BUTTE REGIONAL TRANSIT OPERATIONS CENTER

Tenant Improvement

ADDENDUM NO. 1

1/4/2016

SHEET TITLE:
DEMO FLOOR PLAN
SCALE: 1/8" = 1'-0"

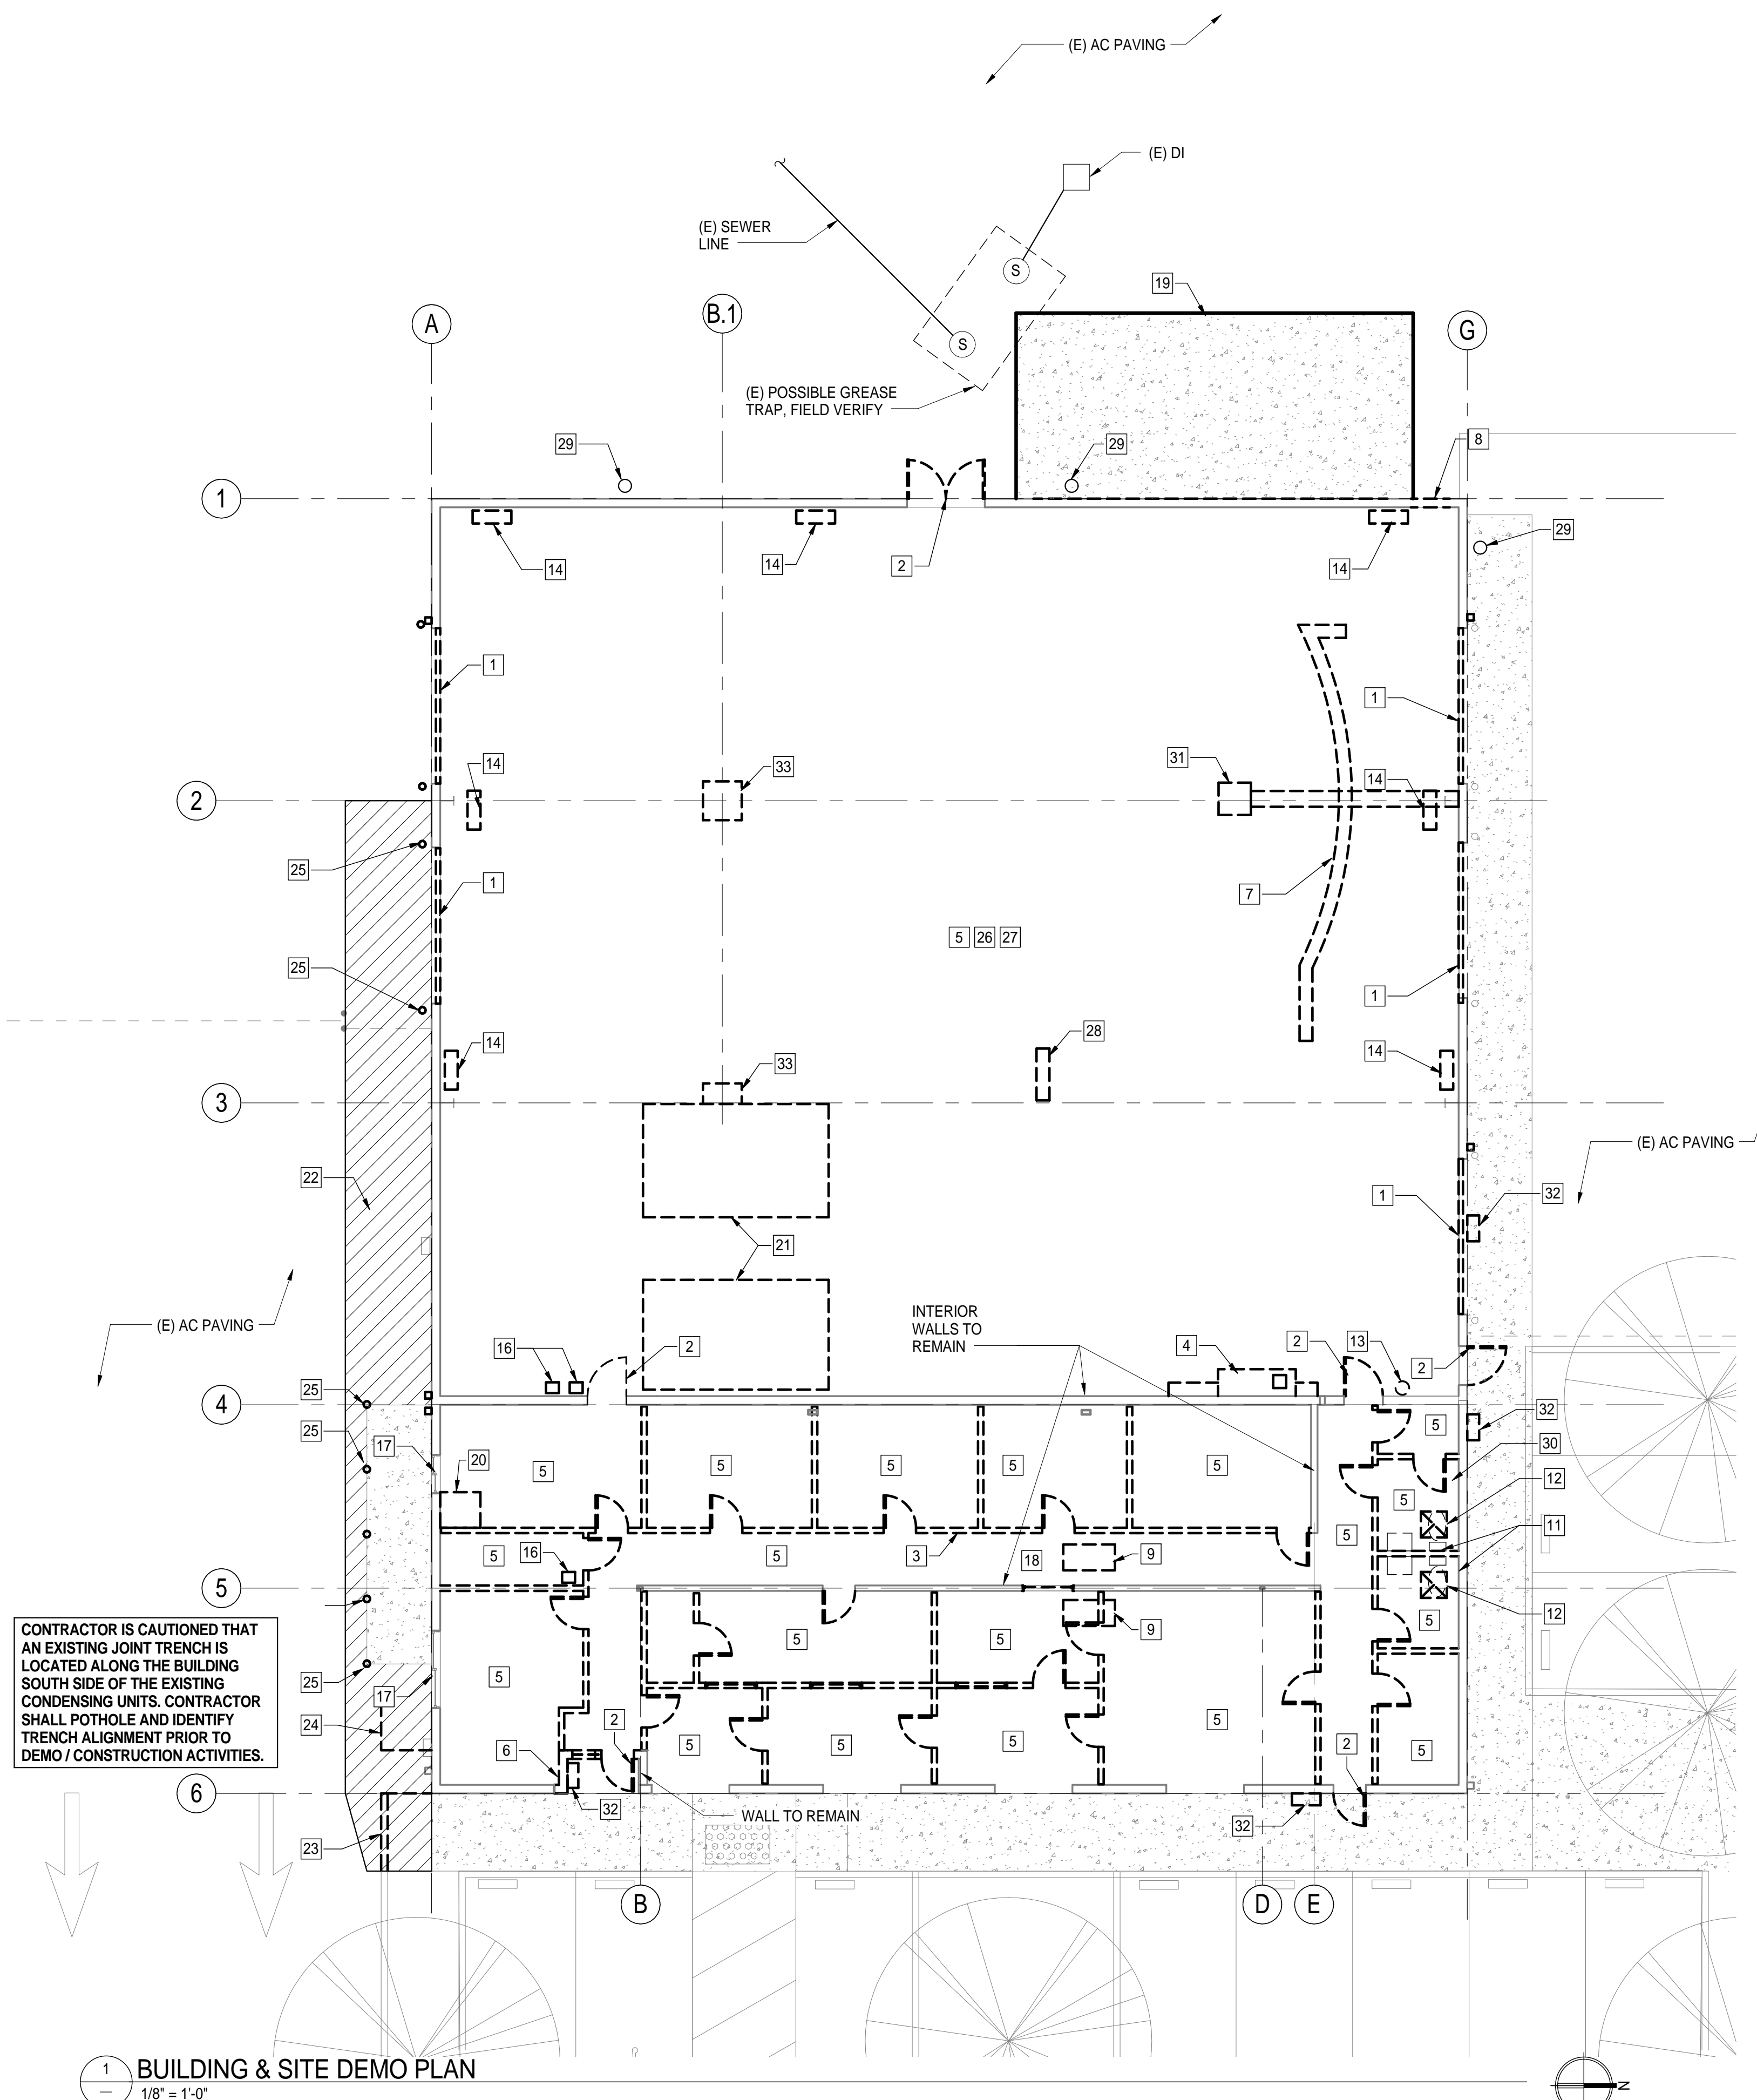
- 1.1 REVISION TO DRAWING AD201 – DEMO FLOOR PLAN
 - a. Revise Keynote 2 to read – (E) DOOR AND FRAME TO BE REMOVED
- 1.2 REVISION TO DRAWING AD230 – DEMO ROOF PLAN
 - a. Keynoting revised, all gutters and downspouts to be removed and replaced within the scope of the project

**ENLARGED FLOOR
PLANS**

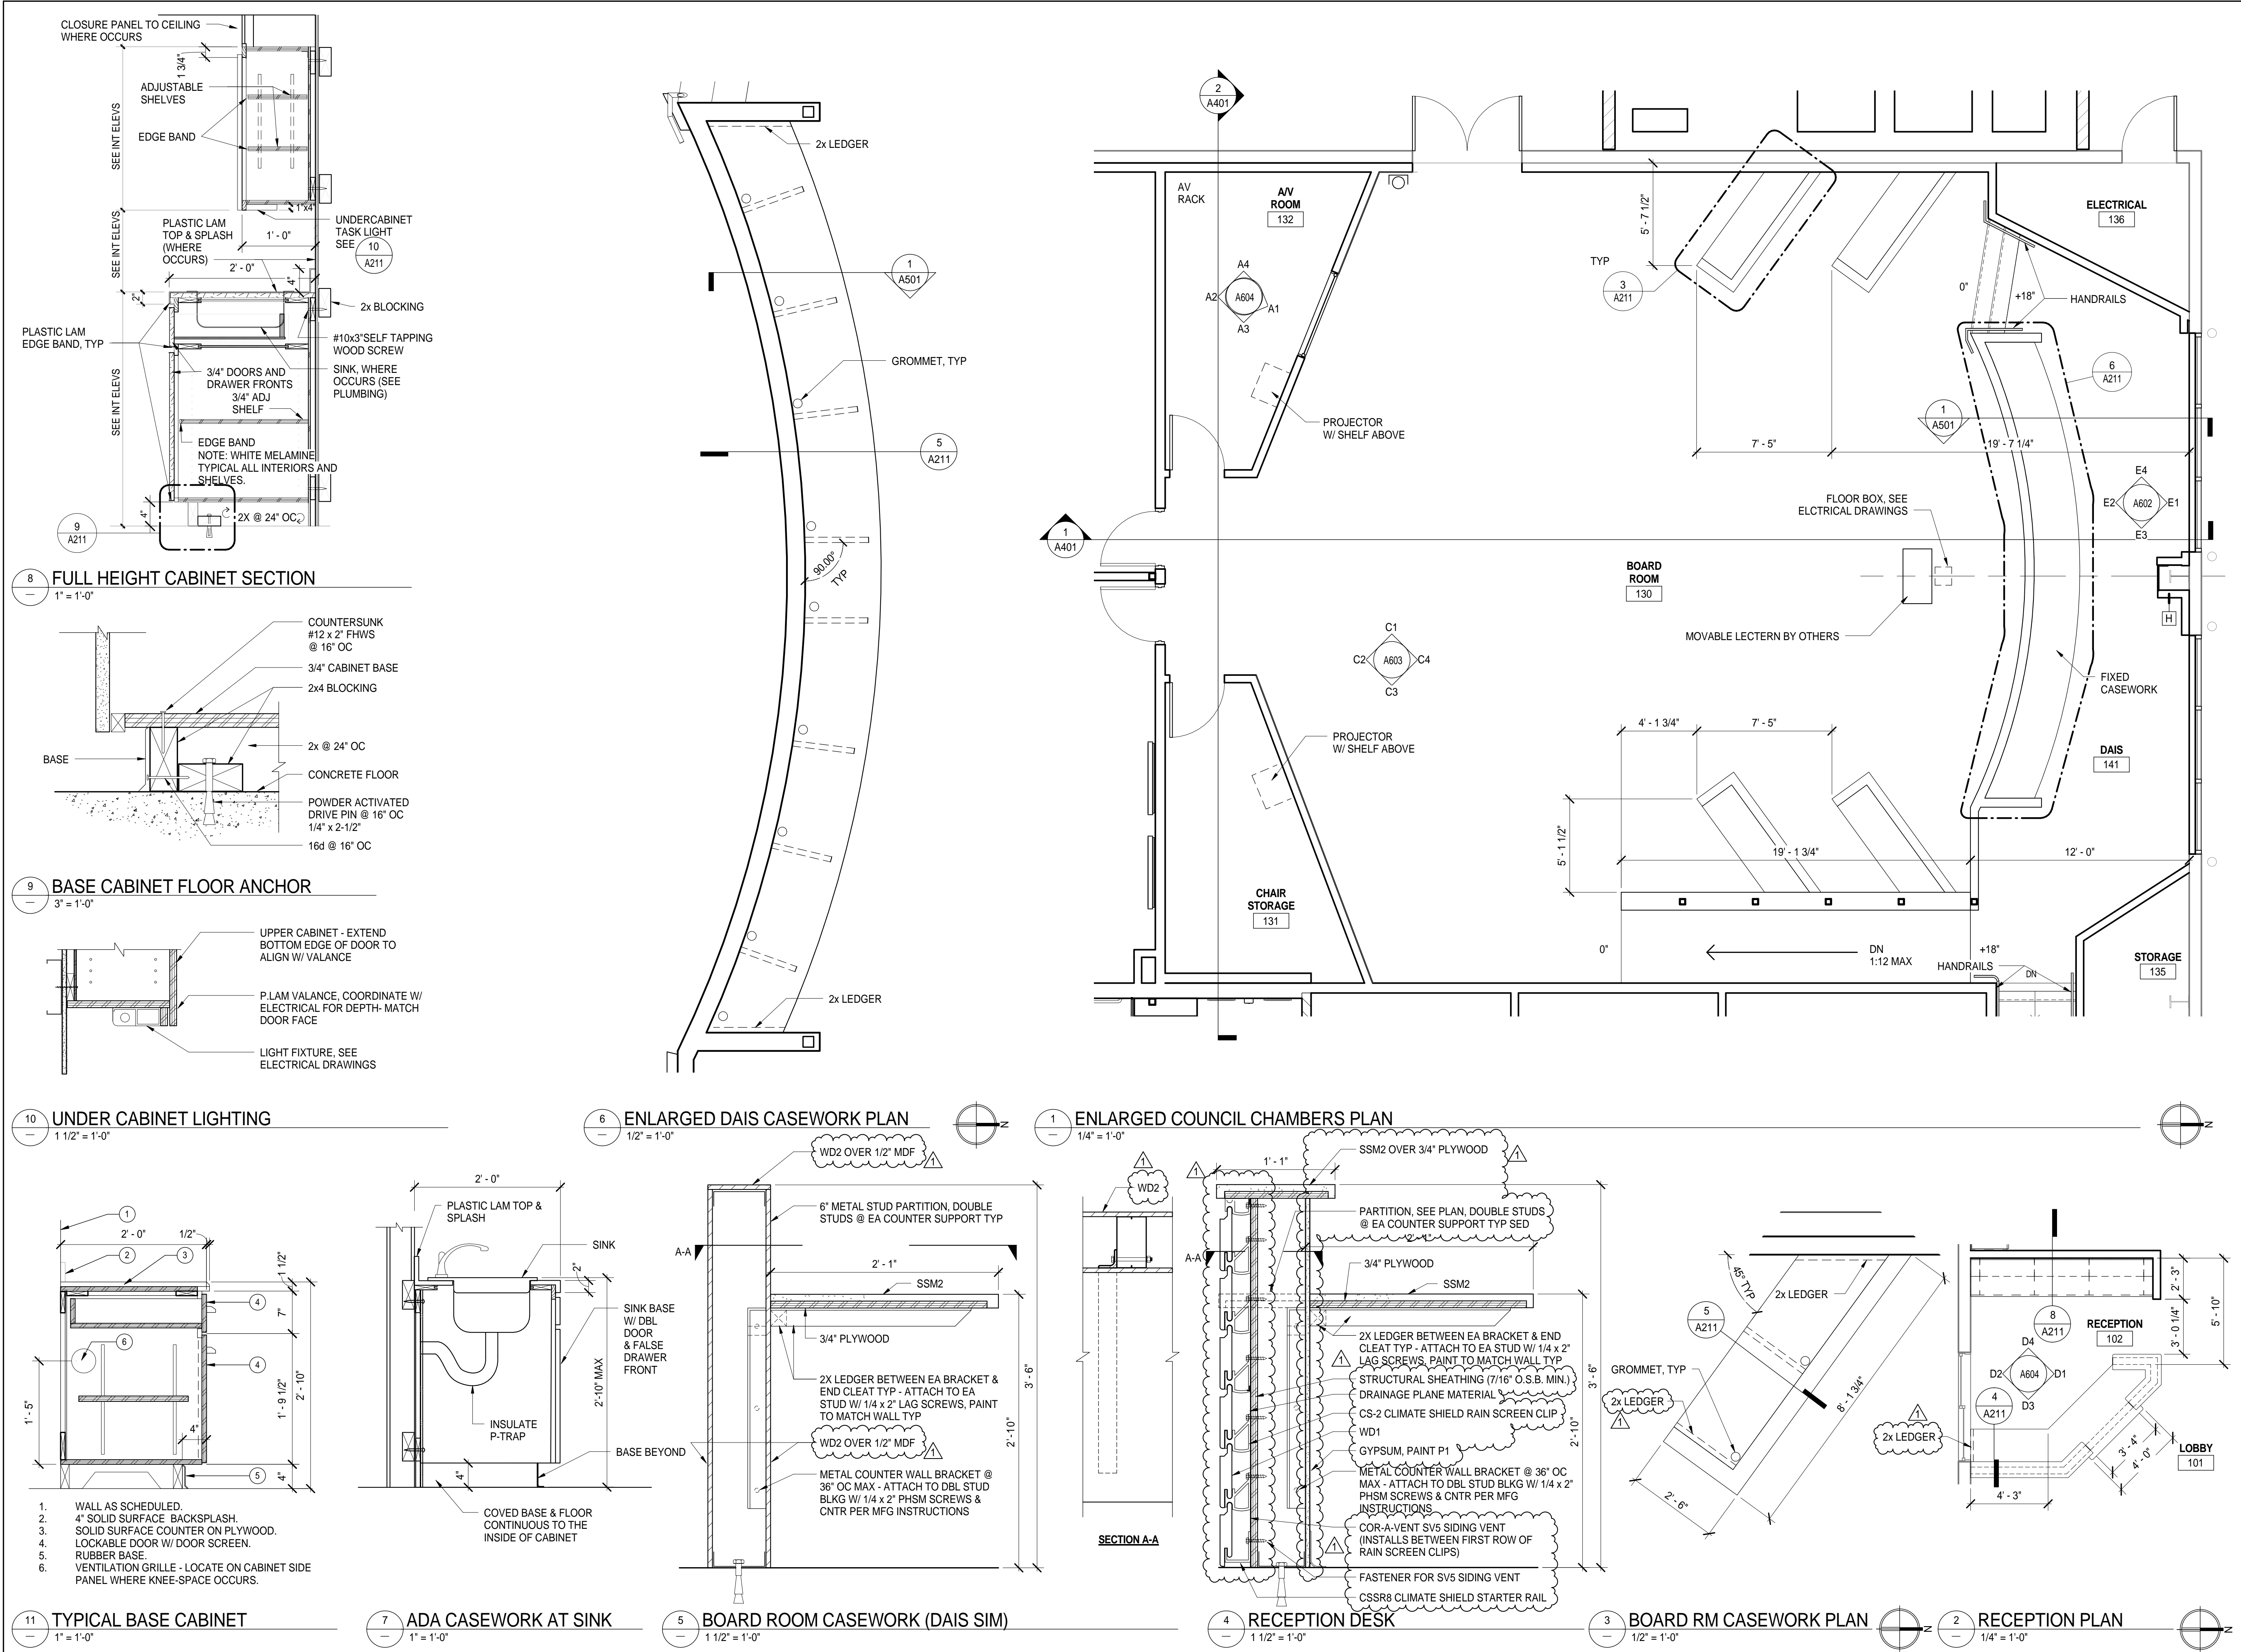
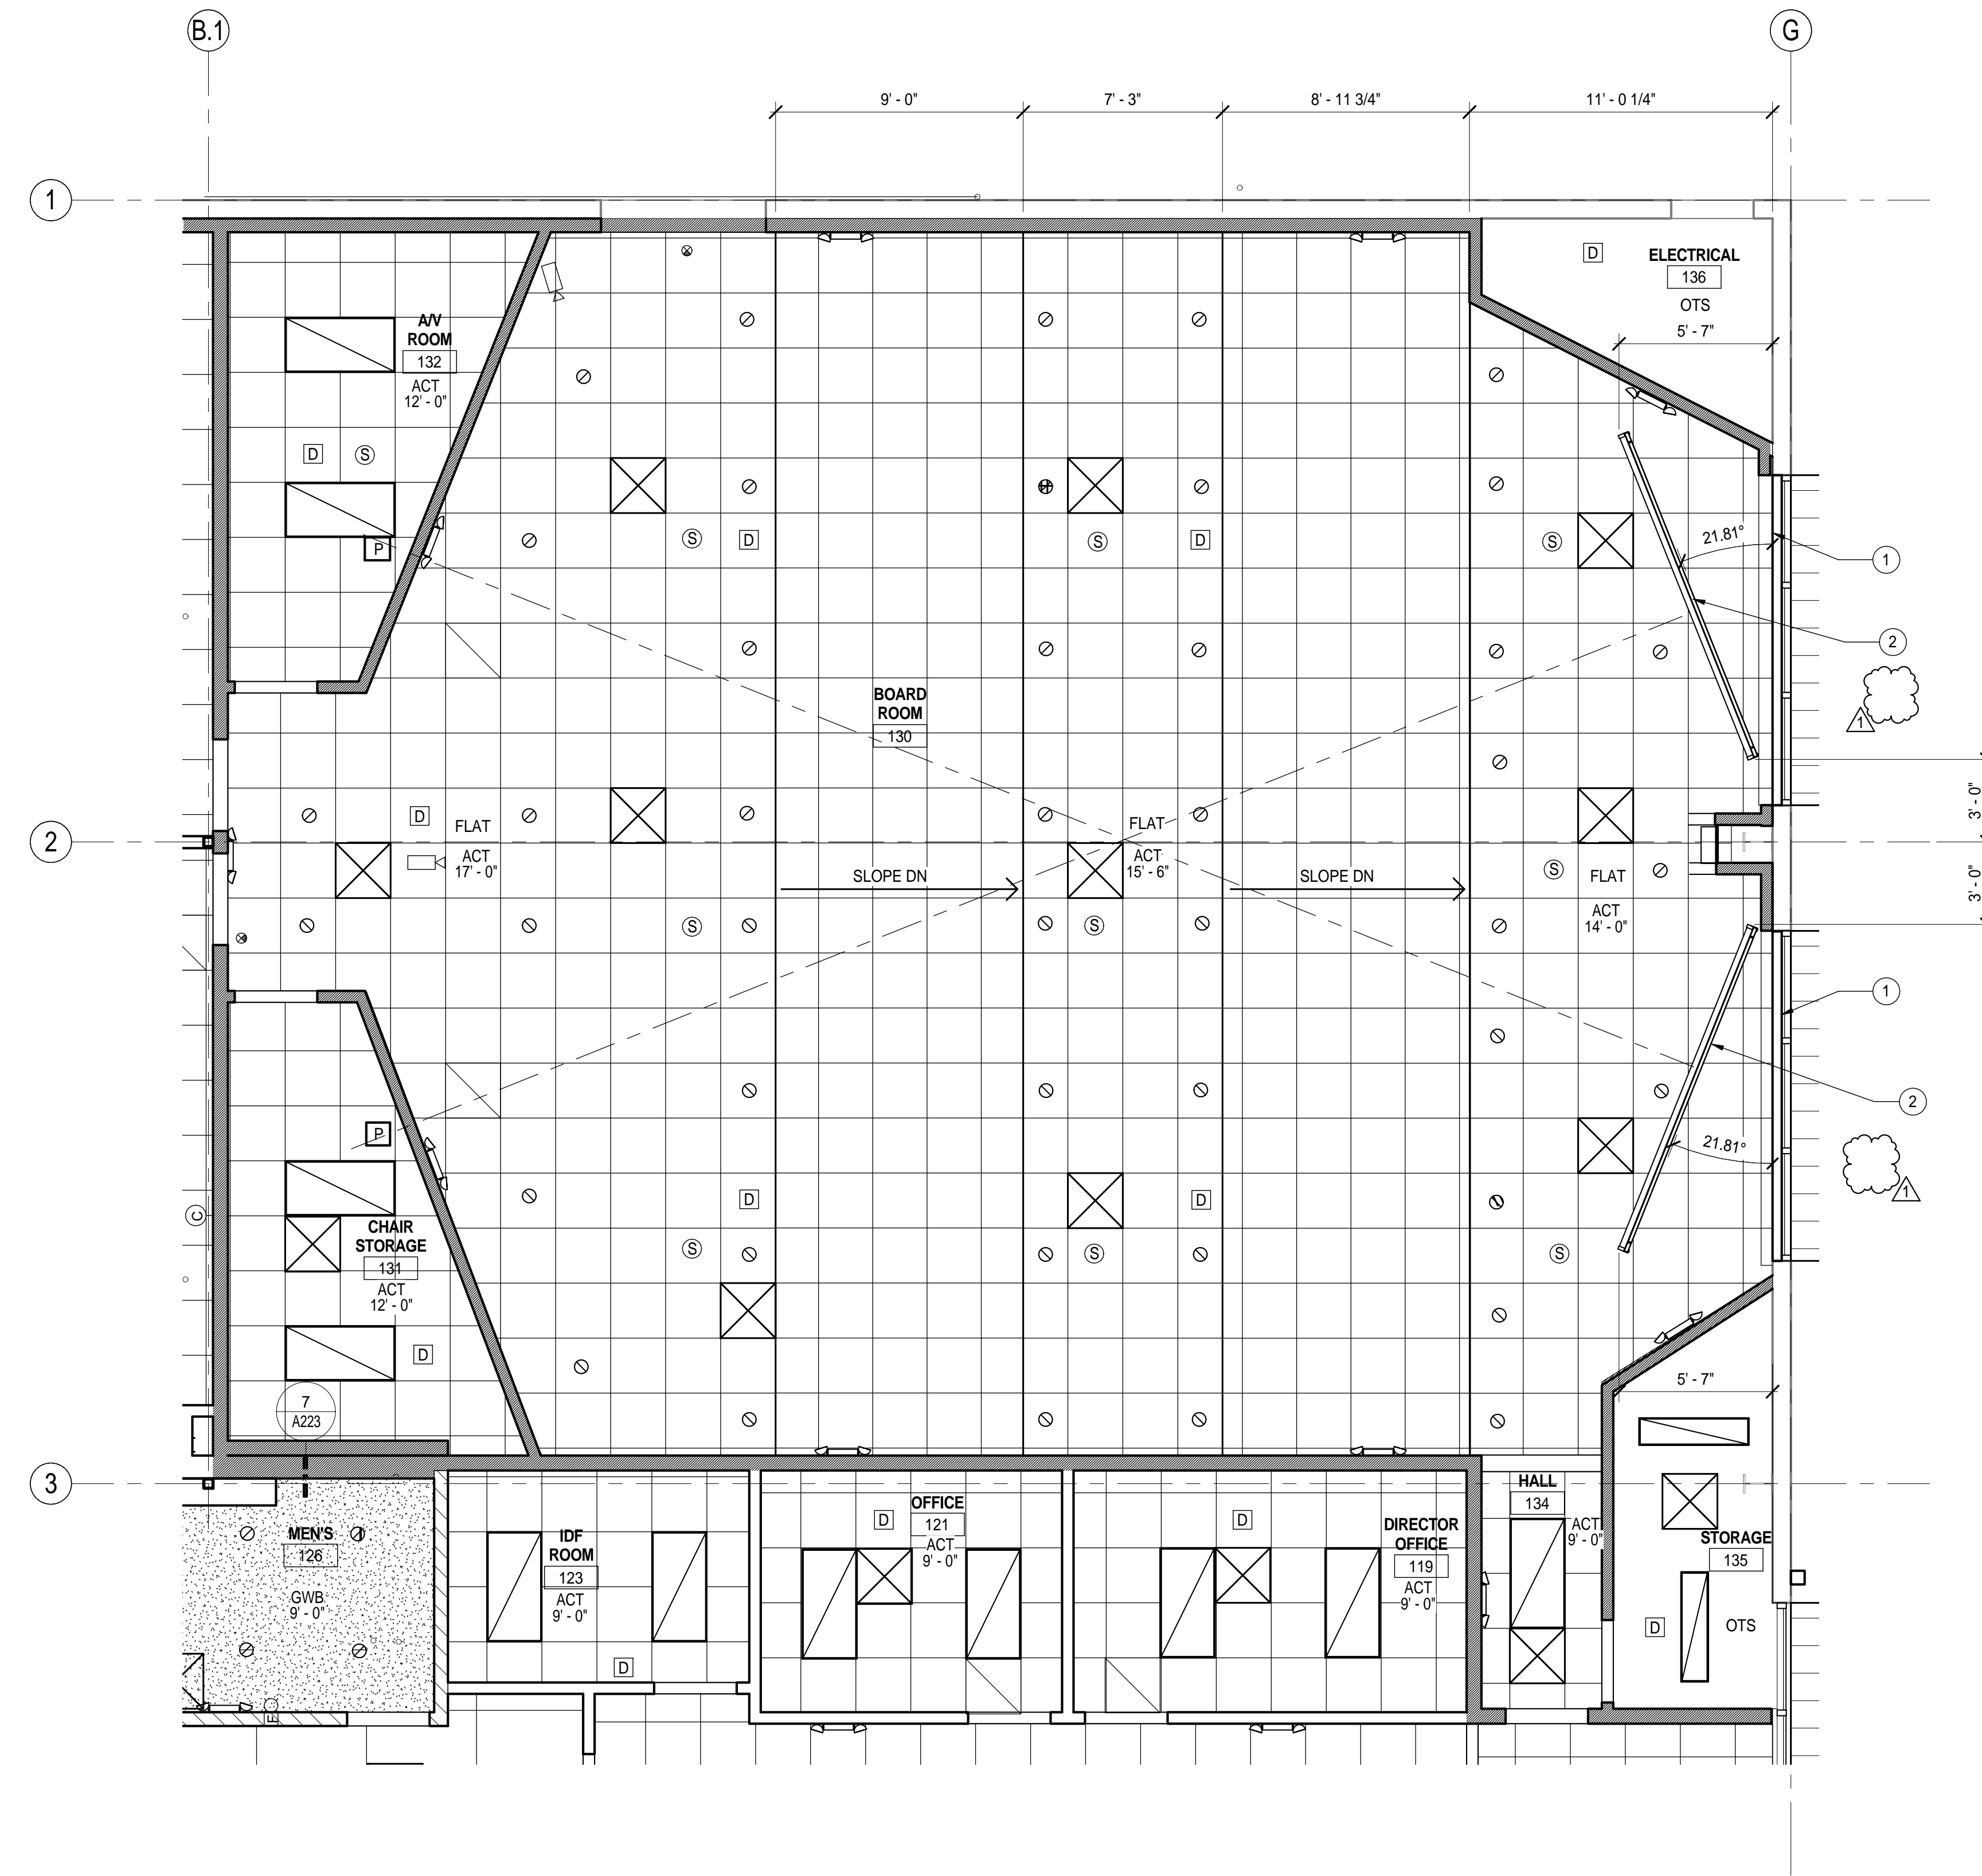
- 1.3 REVISION TO DRAWING A211 - ENLARGED FLOOR PLANS
 - a. Detail 2 - 2x ledger added
 - b. Detail 3 - 2x ledger added
 - c. Detail 4 - Revised to clarify the construction of the reception desk

- d. Detail 5 - Revised to clarify finish material and substrates to be used
- 1.4 REVISION TO SHEET A222 - ENLARGED CEILING PLAN
 - a. Keynote 3 has been omitted
